CITY OF ALBUQUERQUE

Planning Department Transportation Development Services

Re: Advanced Auto Parts, 4910 Central Ave SE Request for Certificate of Occupancy- Transportation Development Architect's Stamp dated 06-18-15 (K17-D110) Certification dated 12-17-15

Re: Advanced Auto Parts 6-Month Temporary Certificate of Occupancy- Transportation Development Engineer's/Architect's Stamp dated 6-18-15 (K17-D110) Certification dated 10-13-15

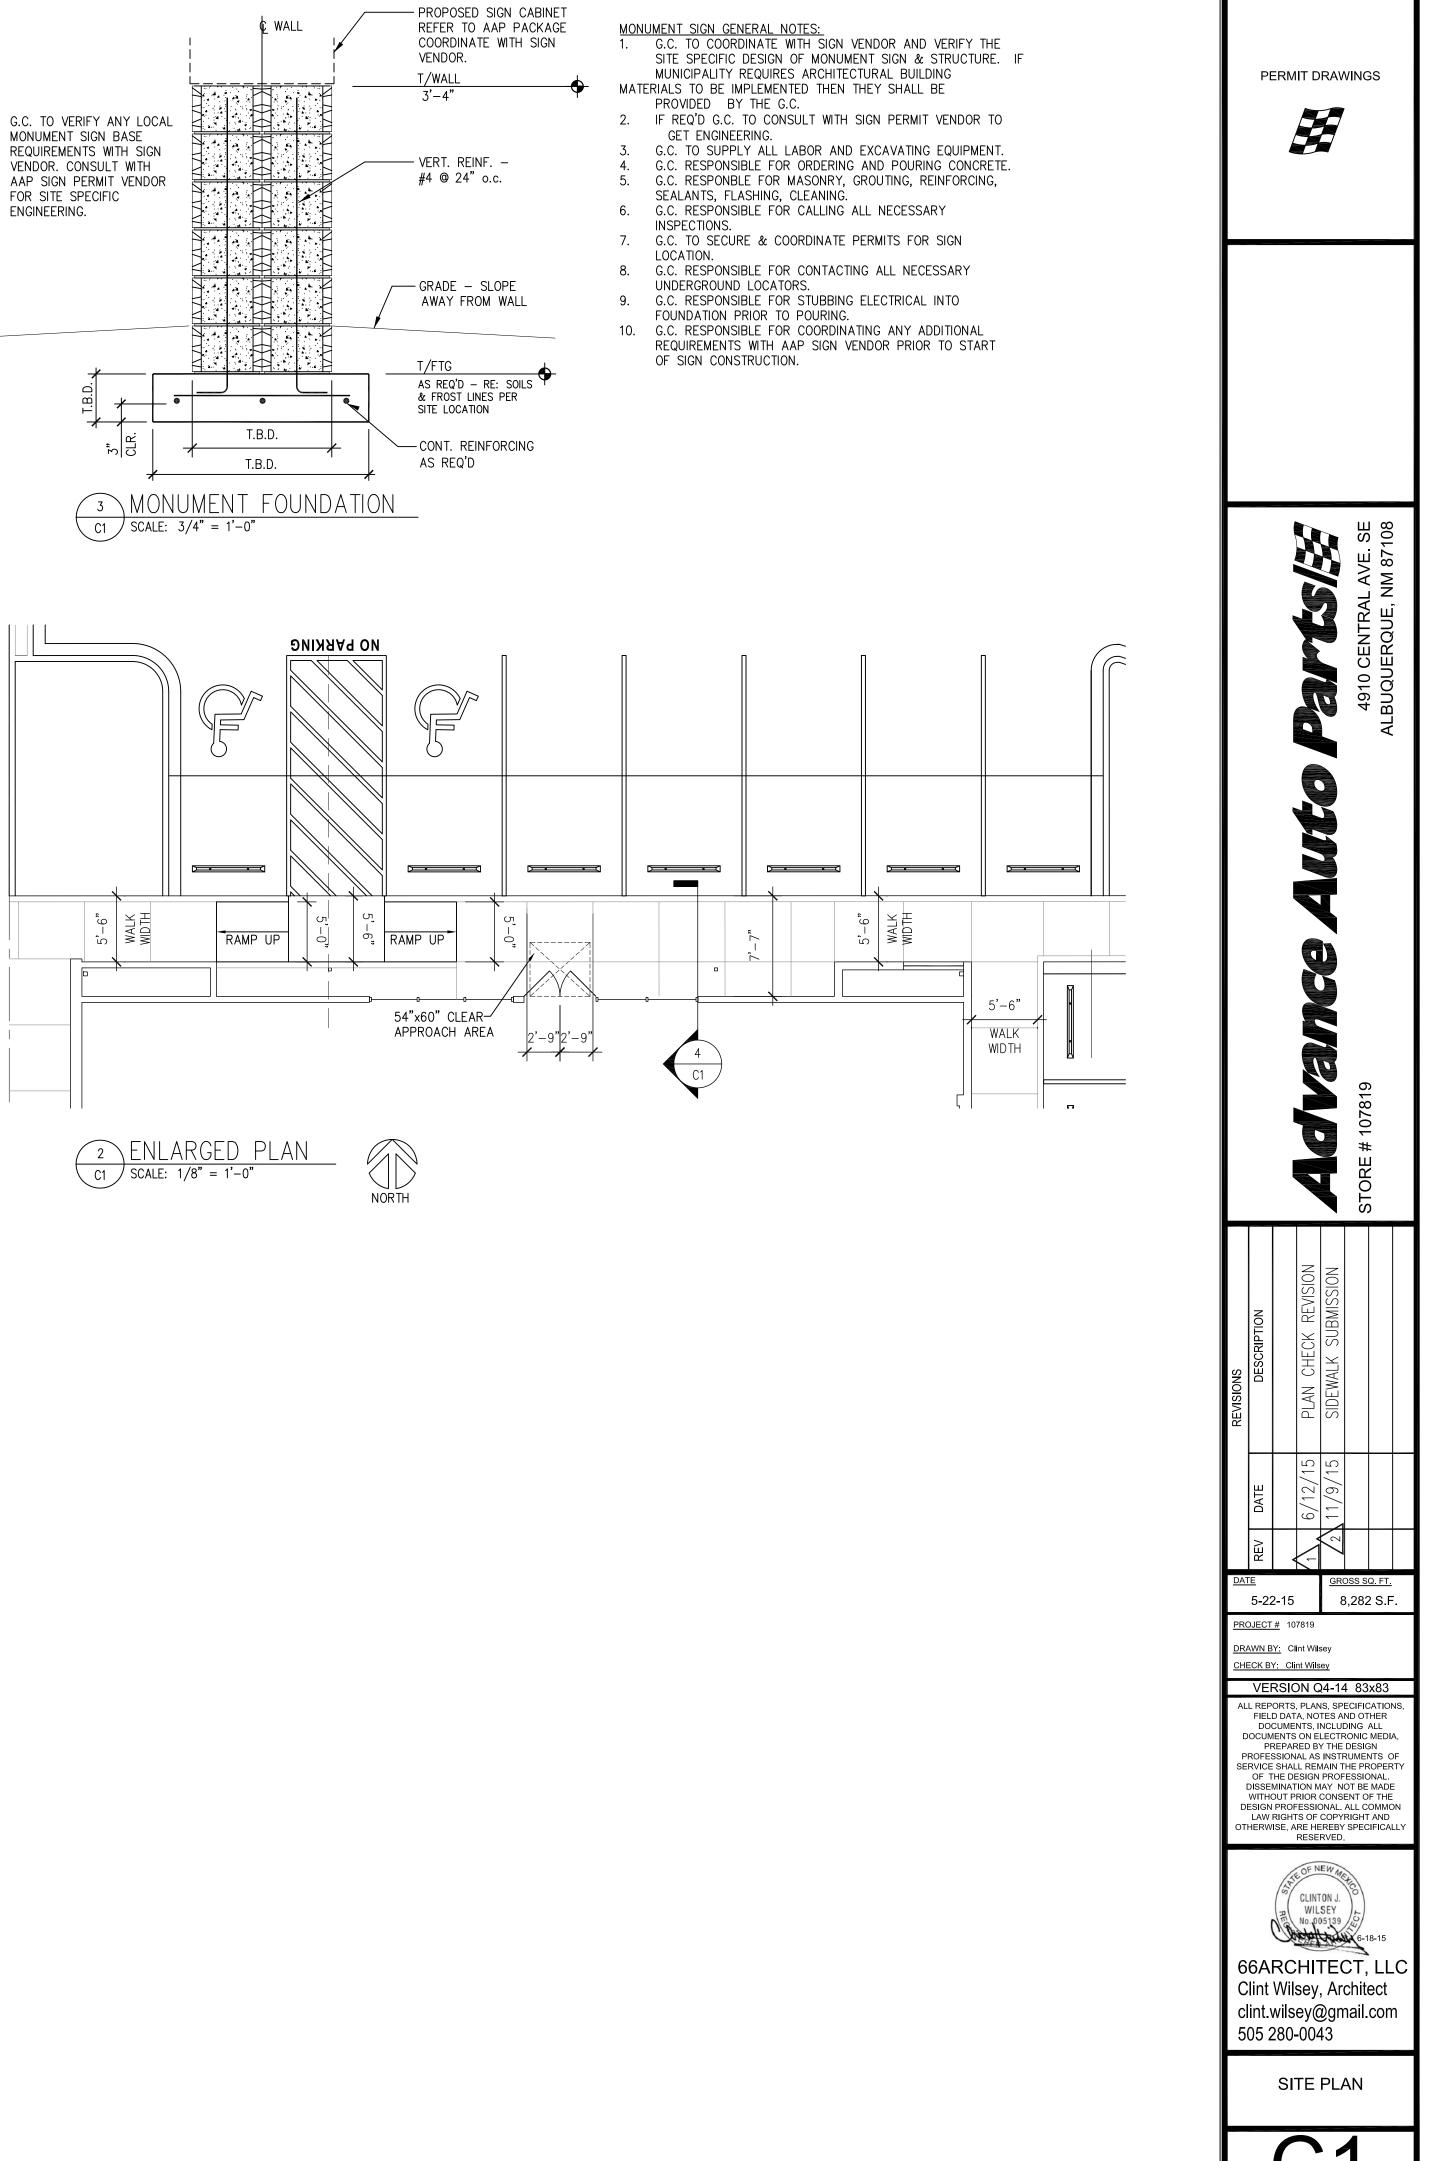
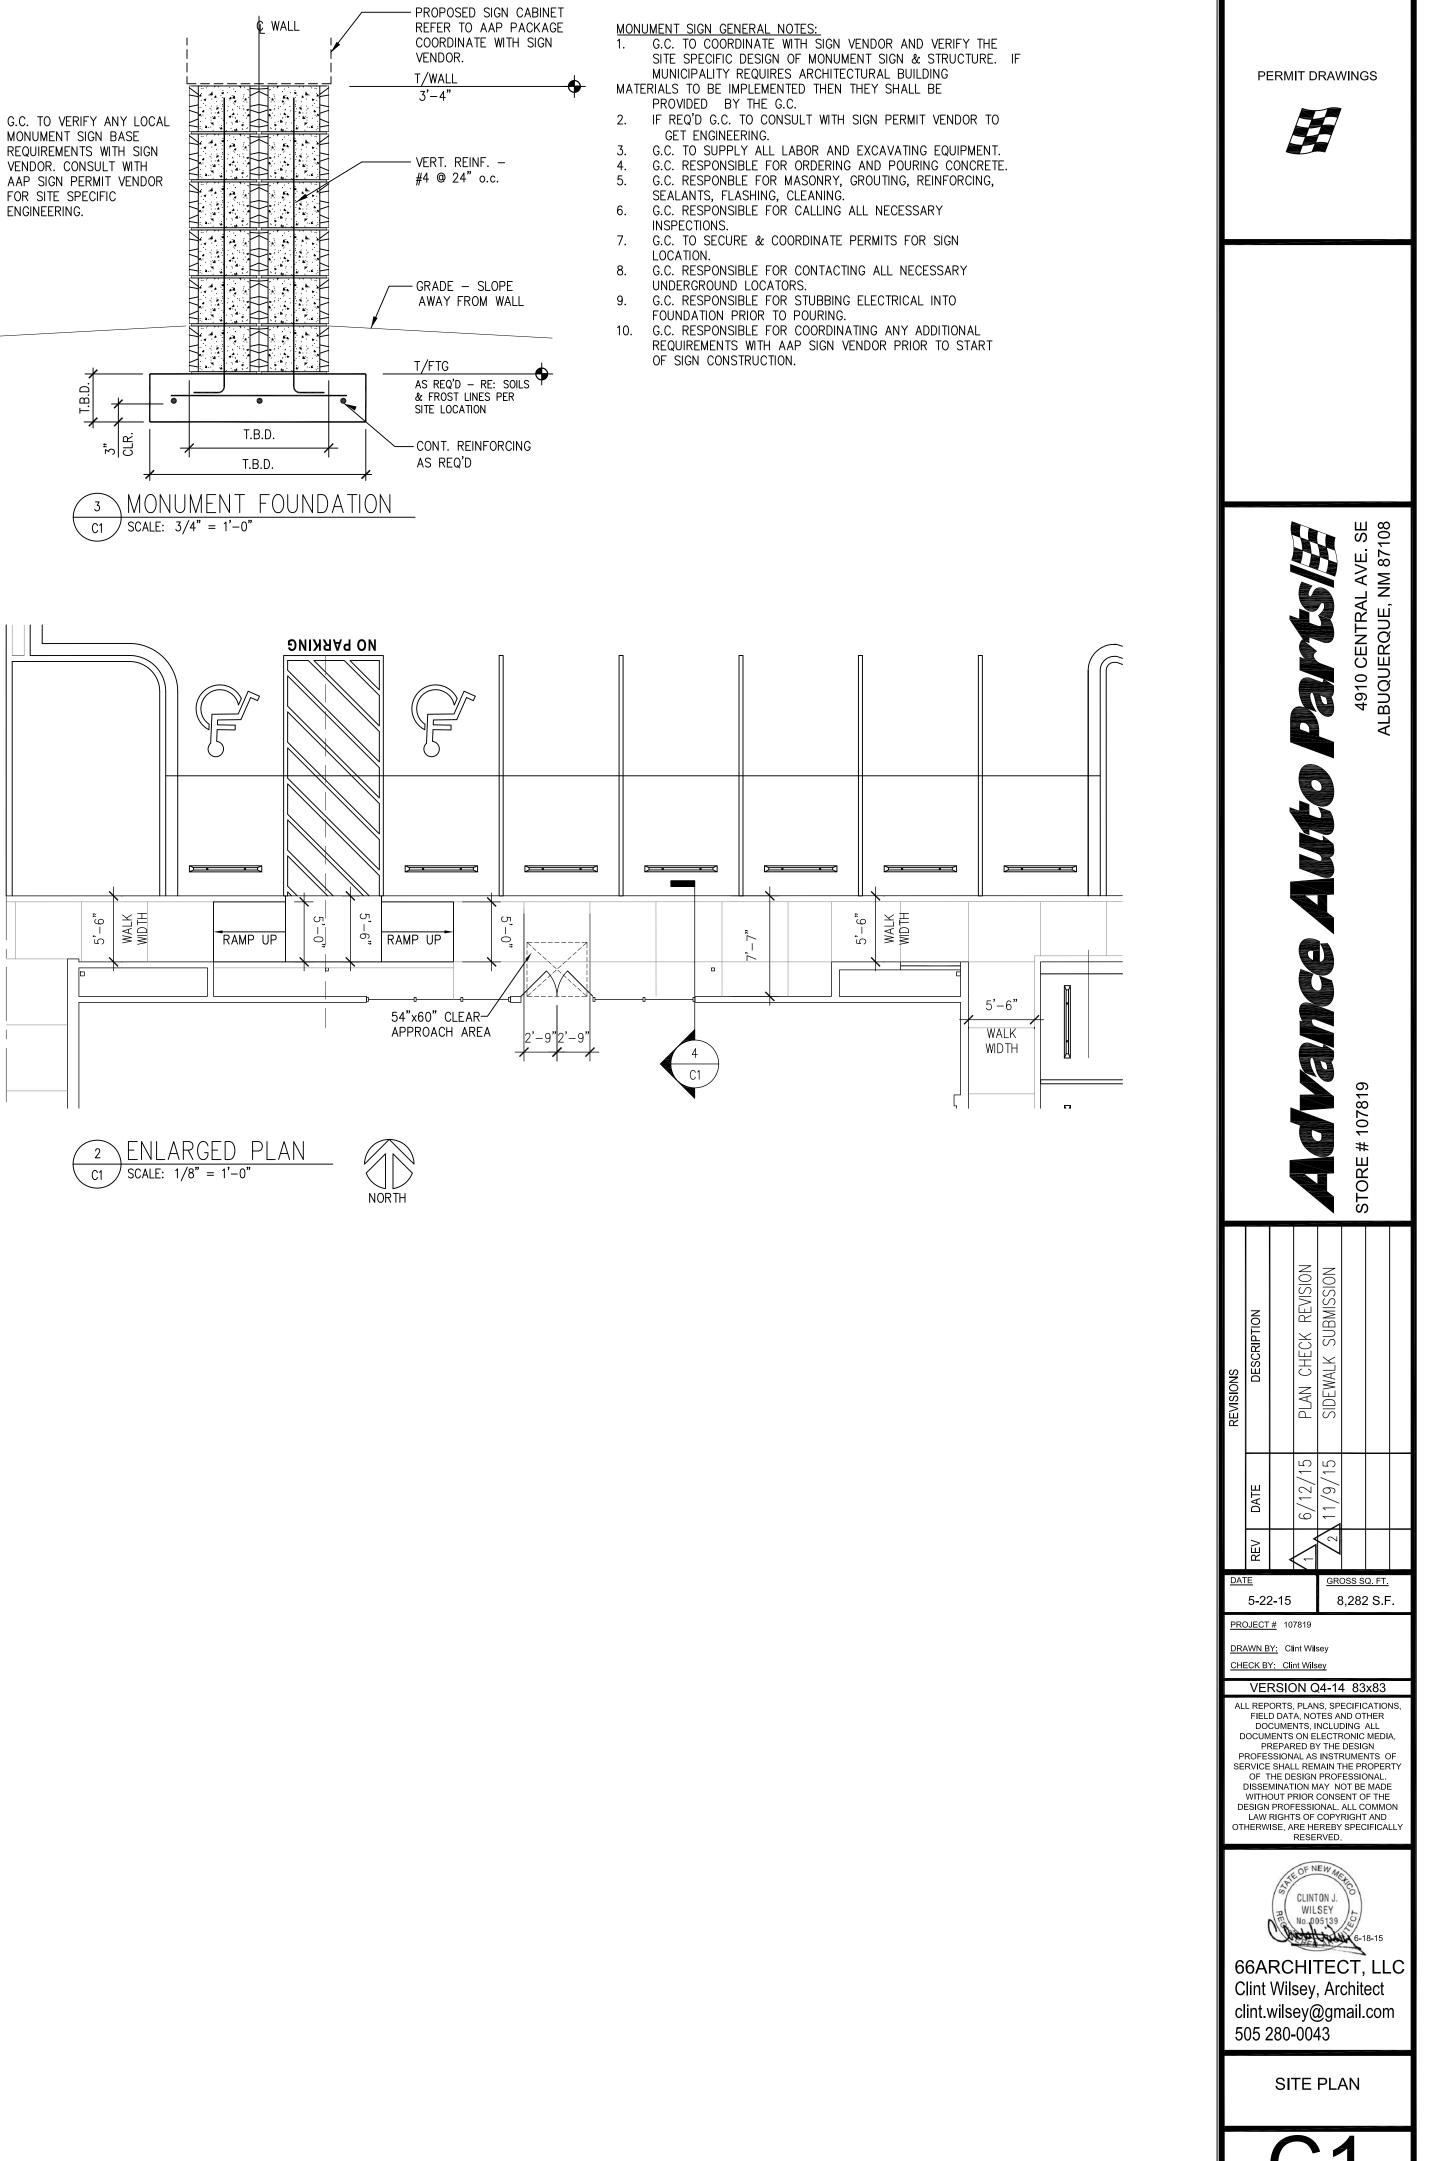
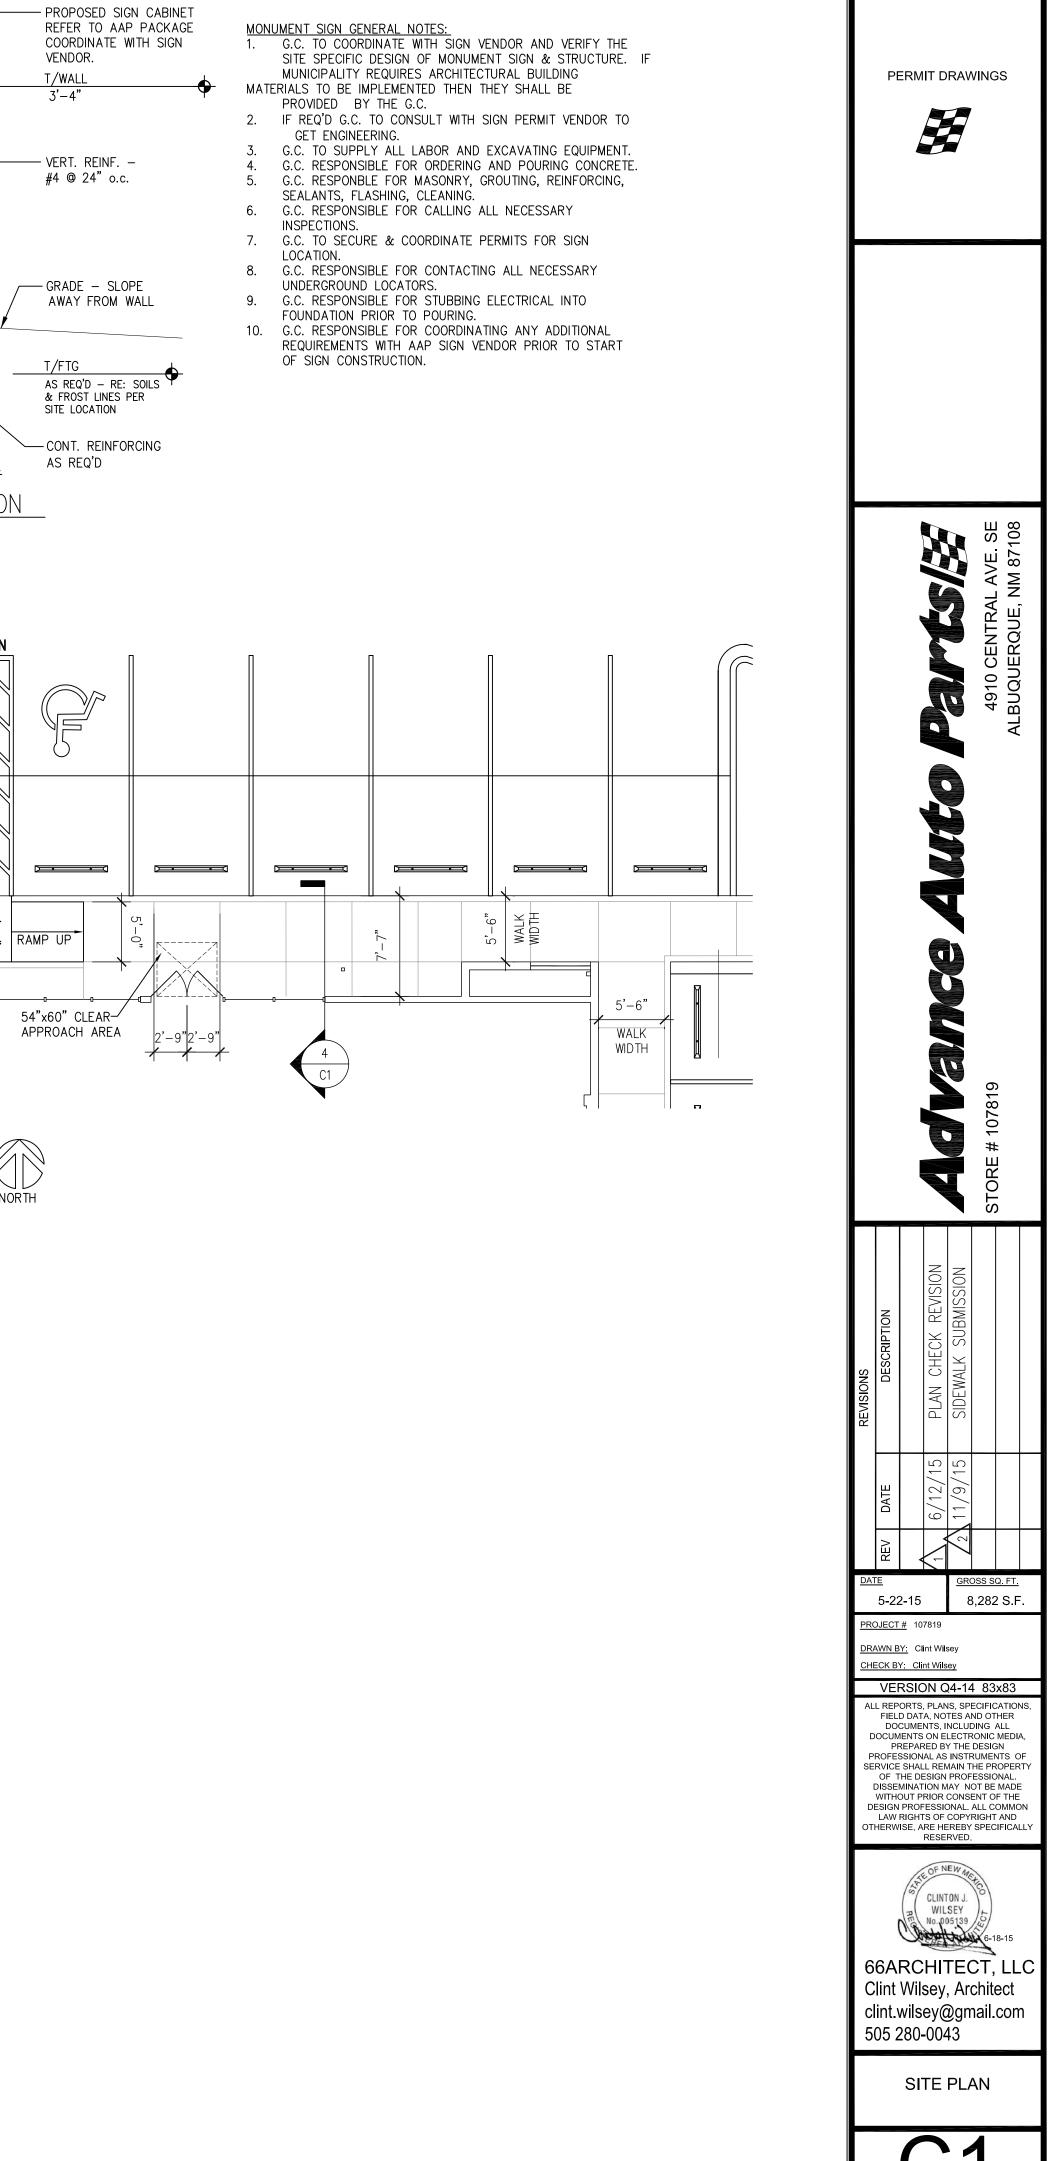
Albuquerque Prior to the issuance of a permanent Certificate of Occupancy, the following items must be addressed:

- Addition of 4 ft. sidewalk along eastern frontage per COA Standards, along with a bump out around existing power pole.
- New Mexico 87103

I, Clint Wilsey NMRA 005139, of the firm 66Architect, LLC, hereby certify that this project is in substantial compliance with and in accordance with the design intent with the TCL and temporary C/0 letter requirements dated 10-20-15. The record information edited onto the original design document has been obtained by Clint Wilsey of the firm 66Architect. I further certify that I have personally visited the site on 4910 Central Ave. SE, Albuquerque, NM and have determined by visual inspection that the survey data provided is representative of actual site conditions and is true and correct to the best of my knowledge and belief. This certification is submitted in support of a request for certificate of occupancy.
